T10/04-029r1, SAS-1.1: Close Port Selector Detection Gap

To: T10 Technical Committee  
From: Robert Sheffield (Robert.L.Sheffield@intel.com), Intel Corporation  
Date: April 29, 2004  
Subject: T10/04-029r1, SAS-1.1: Close Port Selector Detection Gap

Figure 90 — XL (link layer for expander phys) state machine (part 1)

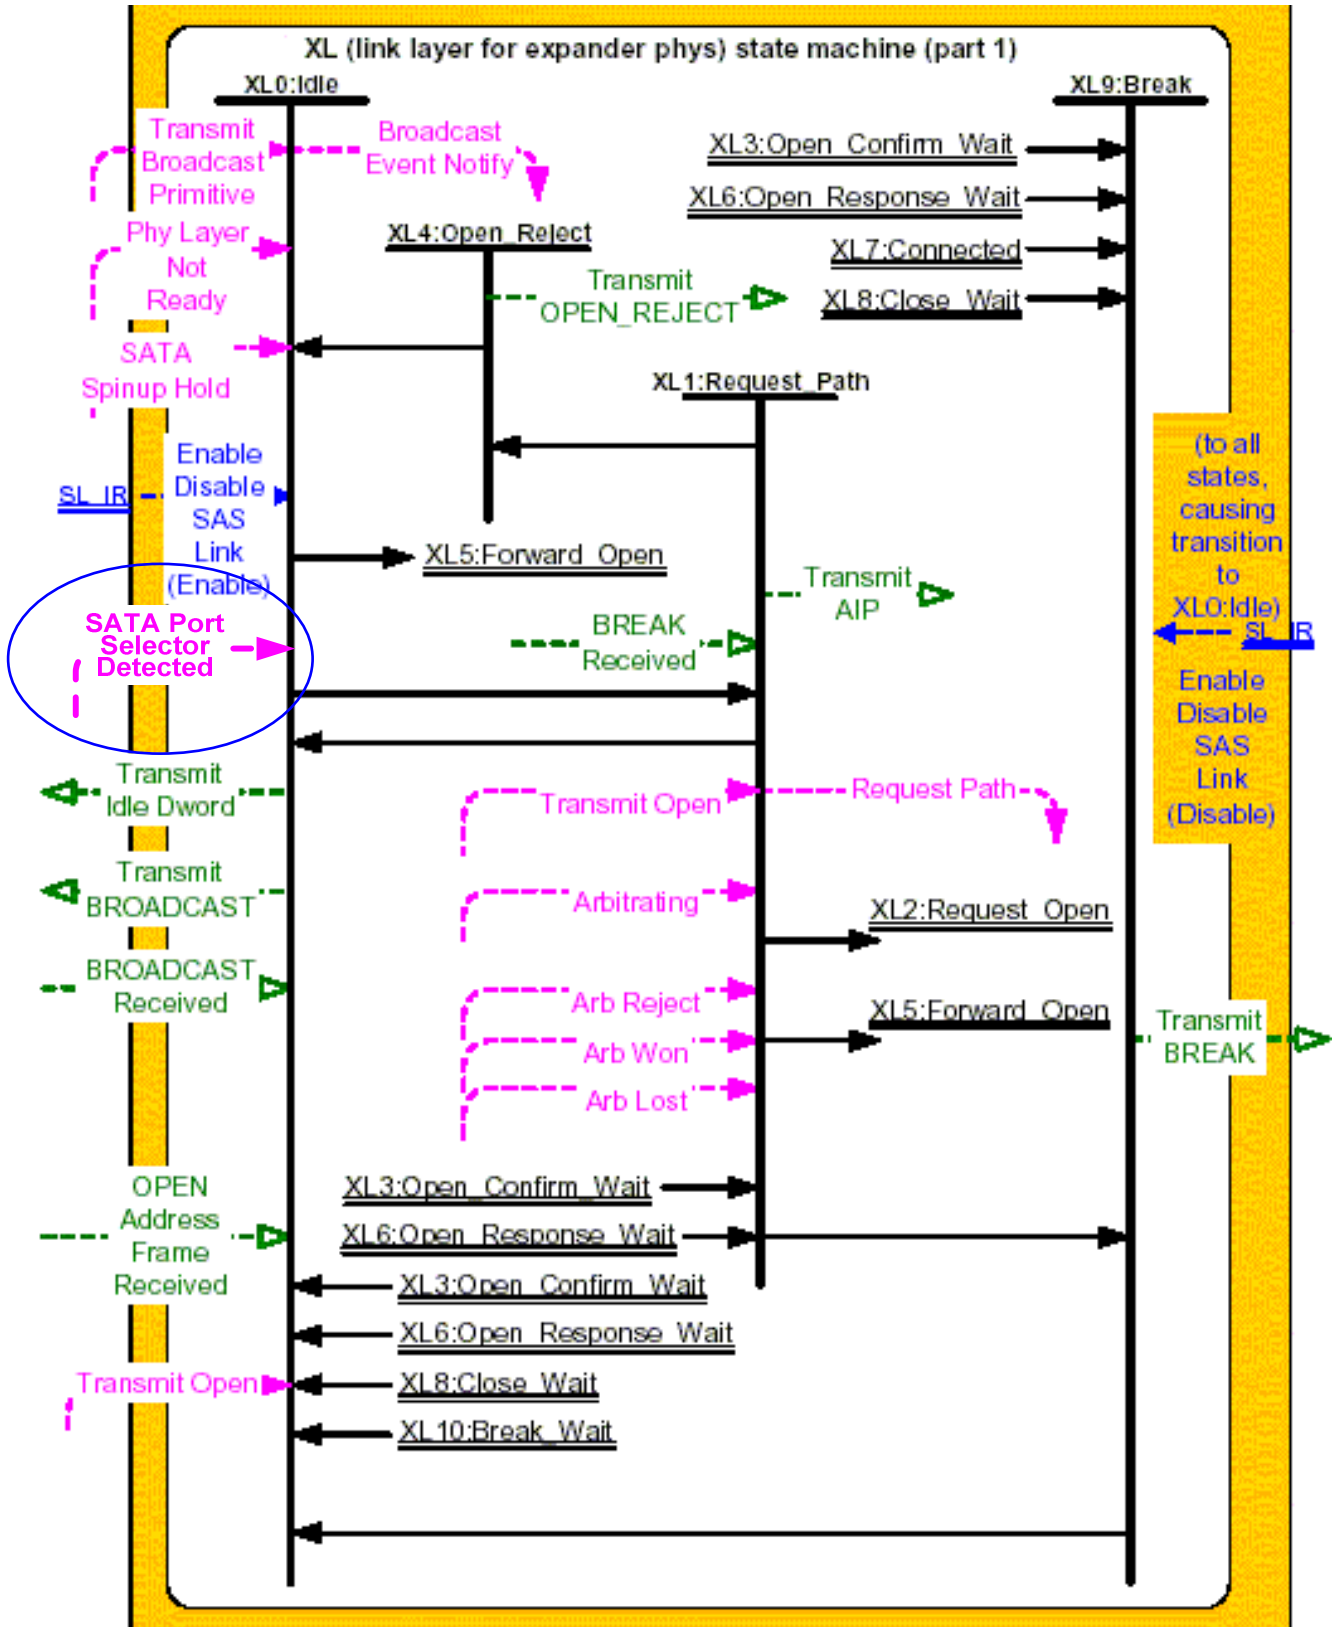
Modify figure 90 in subclause 7.15.1 as follows:

If a SATA Port Selector Detected message is received, this state shall send a Broadcast Event Notify (SATA Port Selector Detected) request to the BPP.
